TECHNICAL EVALUATION REPORT*

MASONRY WALL DESIGN (B-59)

ARKANSAS POWER AND LIGHT COMPANY
ARKANSAS NUCLEAR ONE UNITS 1 AND 2

Figure 1

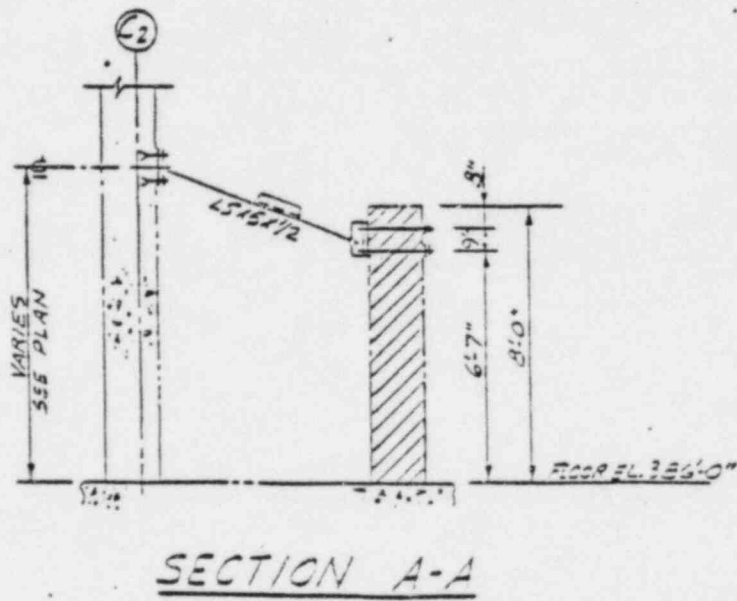
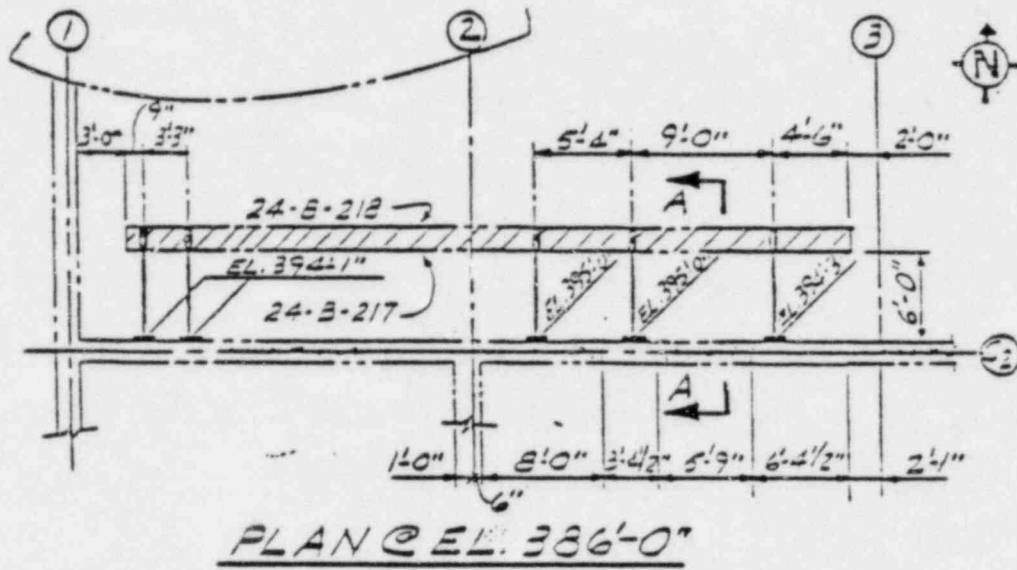
The Licensee has completed modifications for two walls at Unit 2. A simple bracing system was designed and installed for these walls and the reanalysis indicated that modifications brought the responses of these walls within the acceptable level. Locations and configurations of these bracing systems are shown in Figures 1 and 2 of Appendix E.
